Docket: NRC-2018-0052

Holtec International HI-STORE Consolidated Interim Storage Facility Project

RE: **Docket NRC-2018-0052, Holtec HI-STORE
Consolidated Interim Storage Facility Project**

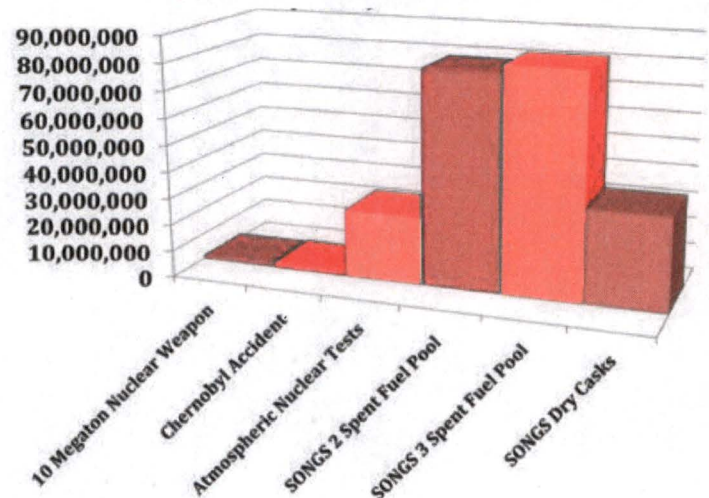
Holtec UMAX lids with large air vents. Round top has outlet air vent. Lower rectangular part of lid has inlet air vents near all corners. Radiation reading at San Onofre were 324 CPM (counts per minute) with no leaks in canister. Carbon-14 is one type of radioactivity released through the air vent. NRC only requires radiation monitoring once a quarter. No monitoring system exists to alert before leaks in canisters.
